HISTORIC AND DESIGN REVIEW COMMISSION

HDRC CASE NO: 2022-492
ADDRESS: 818 AUSTIN ST
LEGAL DESCRIPTION: NCB 991 BLK 1 LOT 6
ZONING: IDZ-3, H
CITY COUNCIL DIST.: 2
DISTRICT: Individual Landmark
APPLICANT: David House /BELEWHOUSE LLC
OWNER: BELEWHOUSE LLC
TYPE OF WORK: Construction of a rear patio cover structure
APPLICATION RECEIVED: September 20, 2022
60-DAY REVIEW: Not applicable due to City Council Emergency Order
CASE MANAGER: Edward Hall

REQUEST:

3 EXTERIOR PATIO EAST ELEVATION (CLOSED O.H.D.)
3/16" = 1'-0"

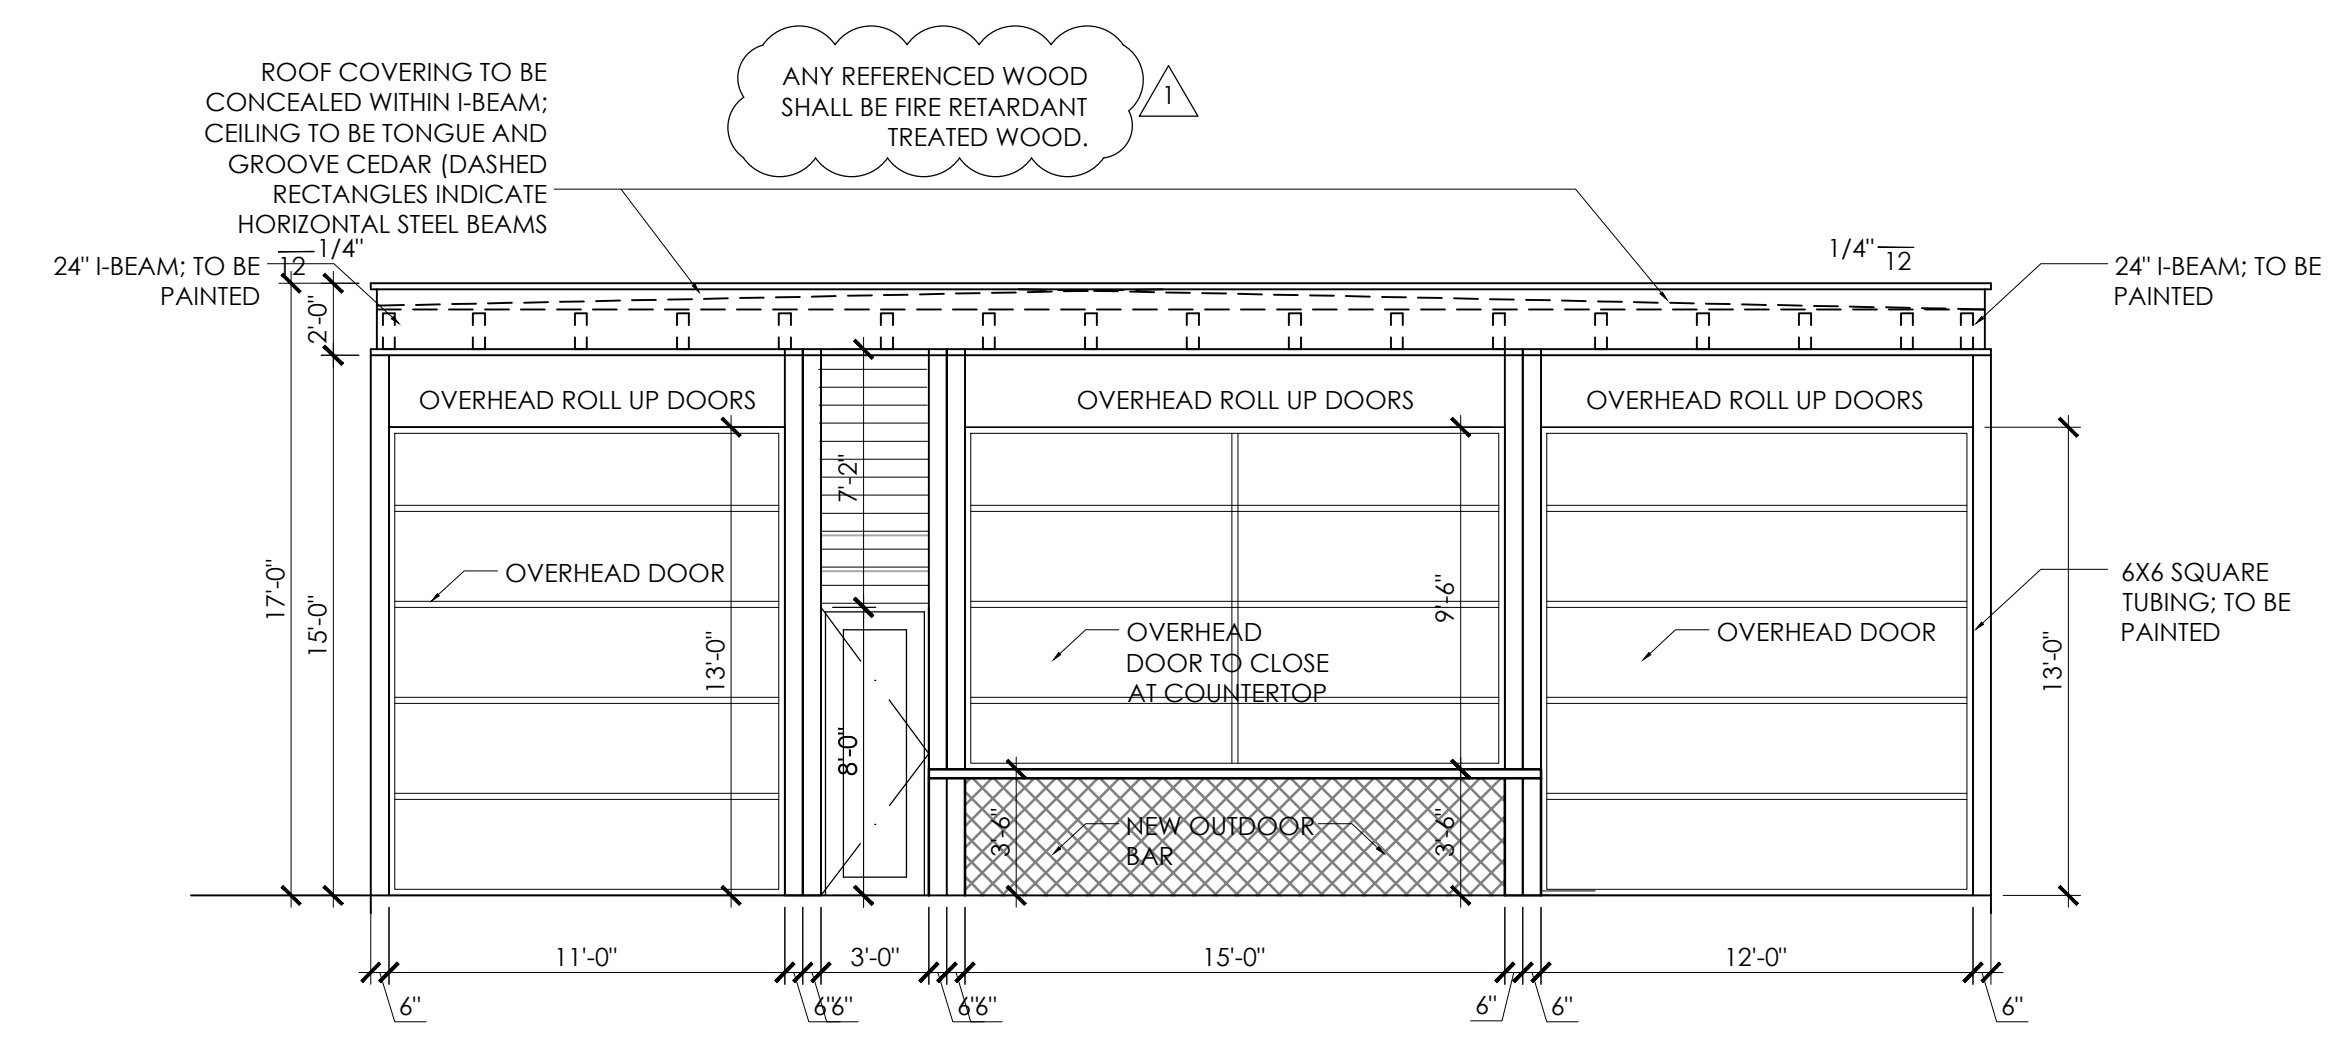
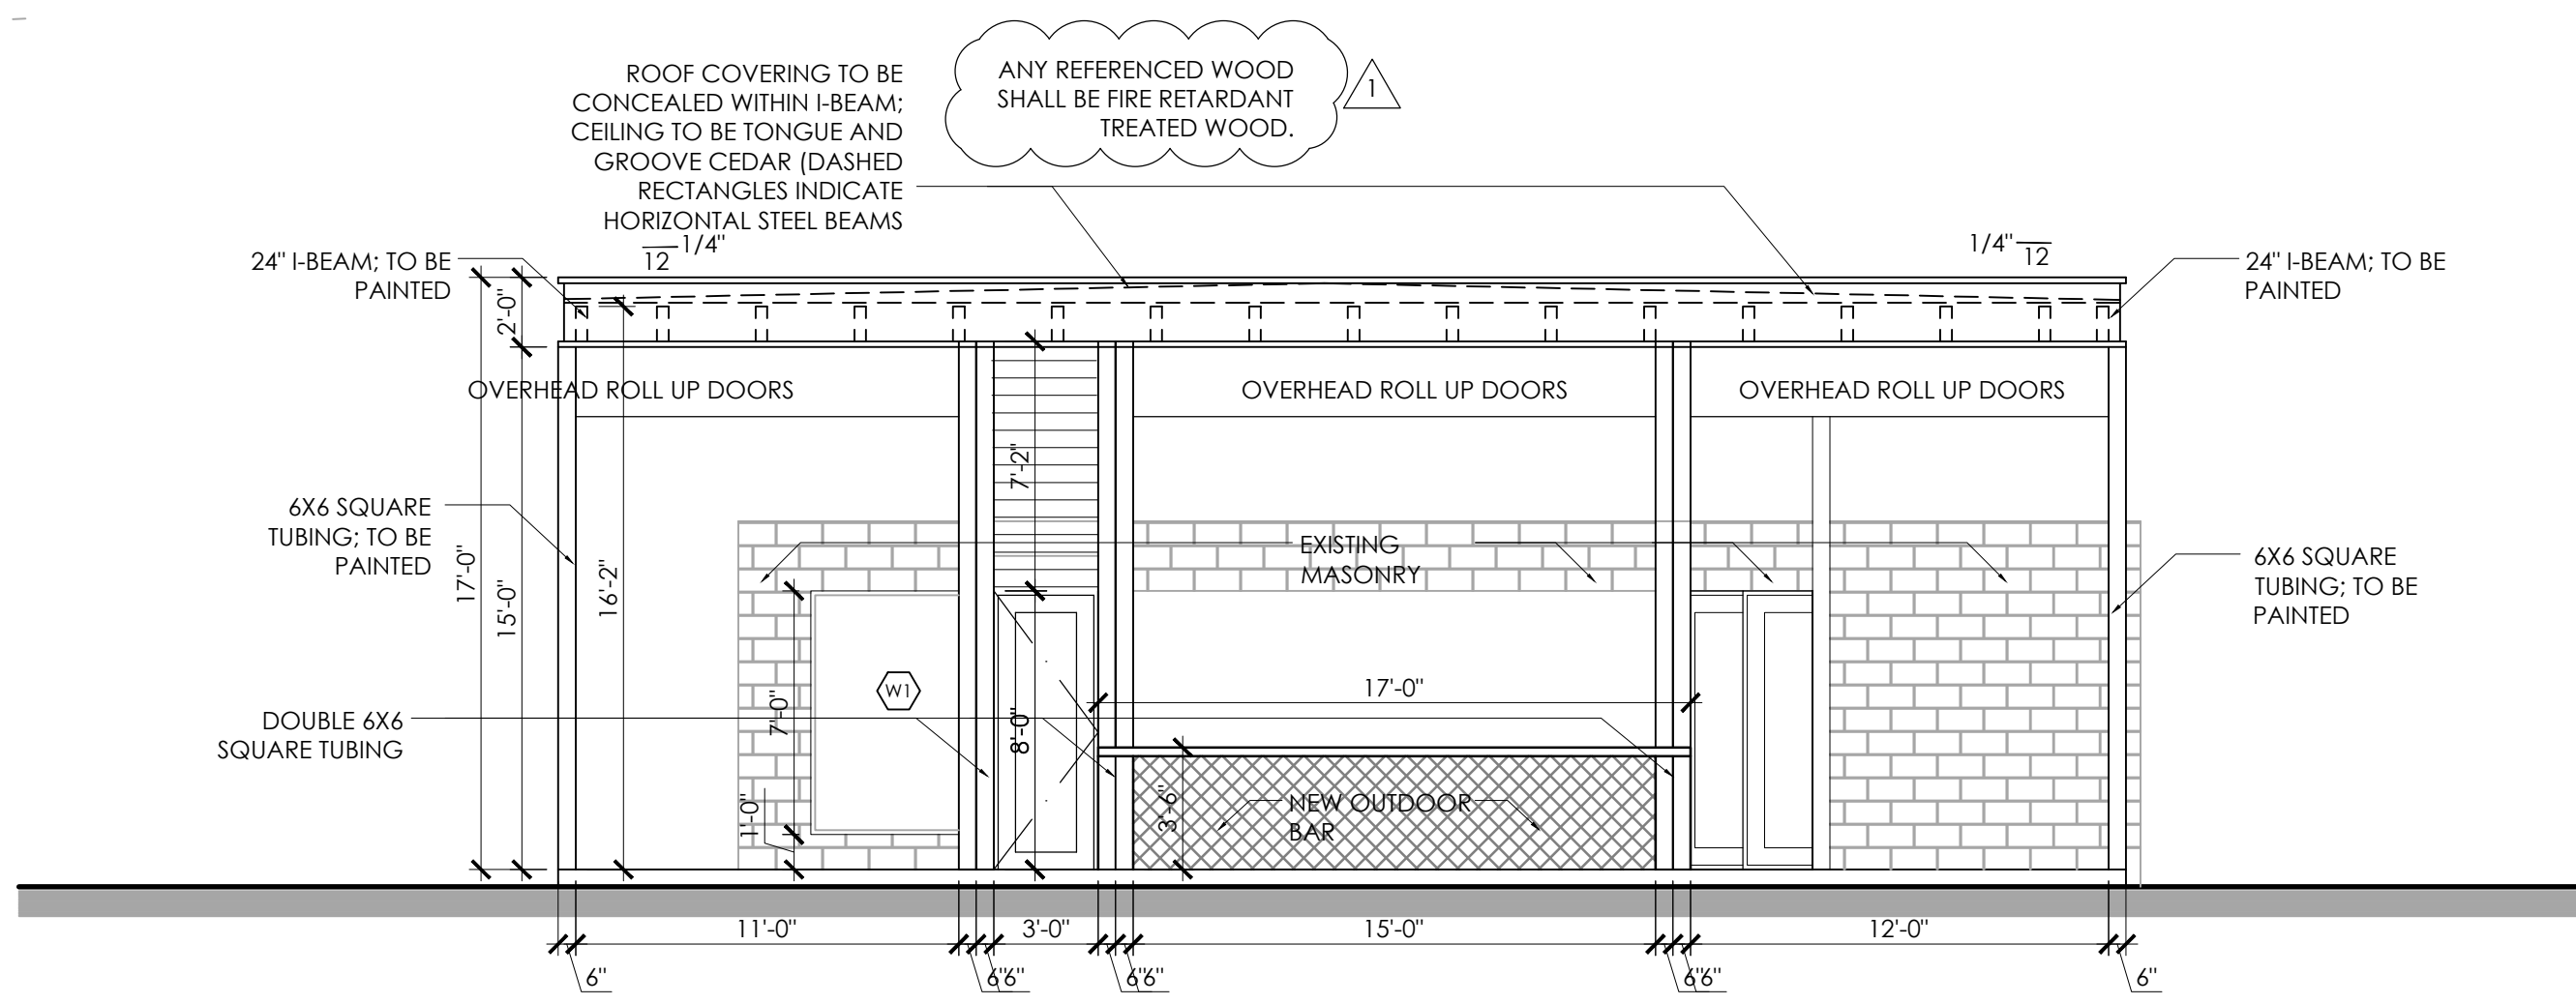
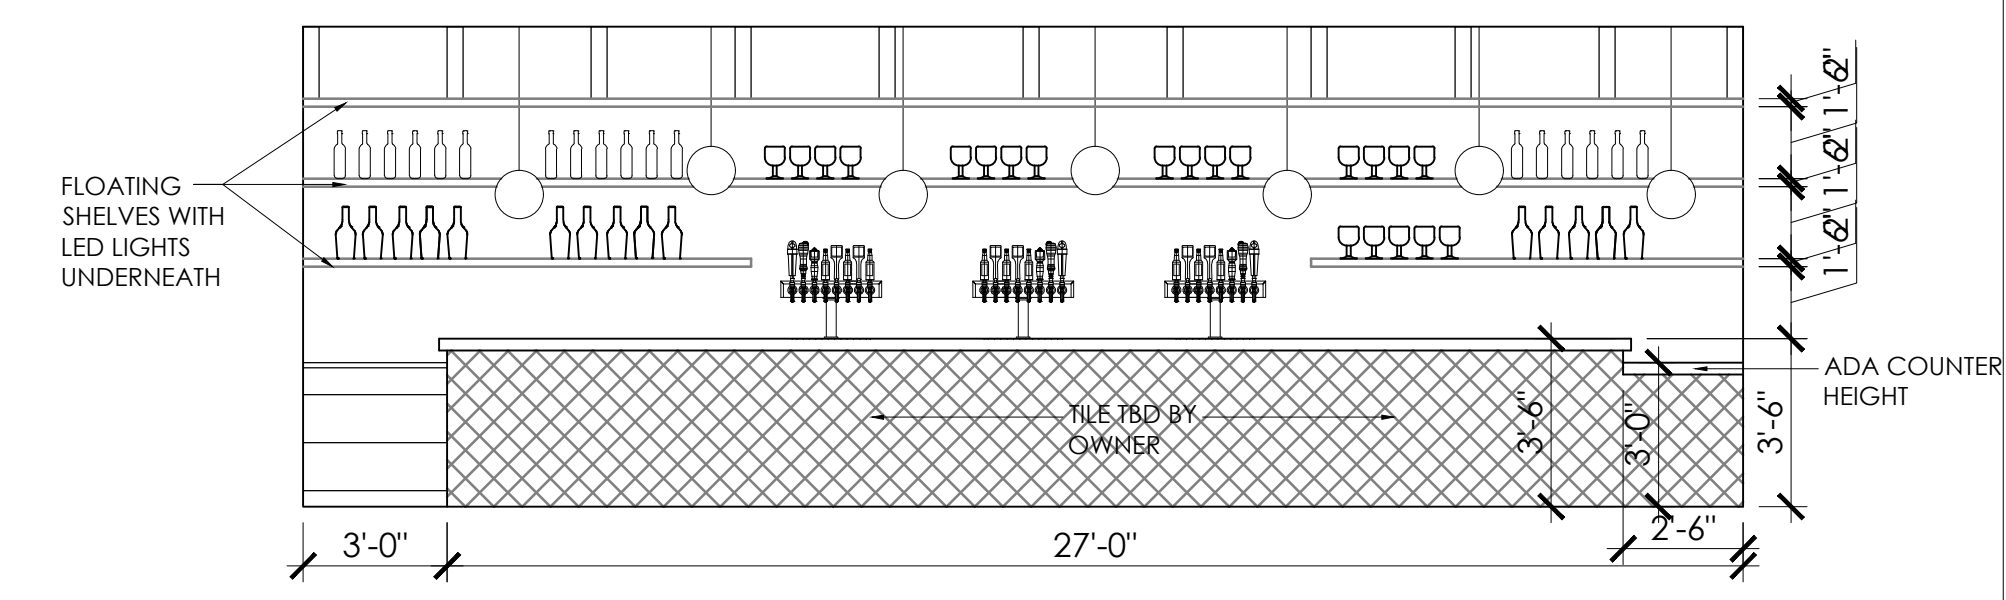
- c. PATIO COVER (Scale & Massing) – The applicant has proposed to construct a patio cover to feature a total footprint of approximately 1,080 square feet. The proposed patio cover will feature an overall height of seventeen (17) feet. Generally, staff finds the proposed size of the proposed patio cover to be appropriate given its location and separation from the primary historic structure on the site.

- d. PATIO COVER (Materials) – The applicant has proposed materials that include square, steel columns, steel wide flange beams, and overhead rolling doors. Generally, given the industrial nature of the vicinity and the existing, rear addition, staff finds the proposed materials to be appropriate. Staff finds that the applicant should submit the overhead rolling garage doors to OHP staff for review and approval prior to the issuance of a Certificate of Appropriateness.

- i. That the applicant submit the proposed overhead rolling doors to OHP staff for review and approval, as noted in finding d. The proposed doors should feature metal construction and should not be vinyl.
- ii. That all structural elements be painted to complement the existing material colors on site.
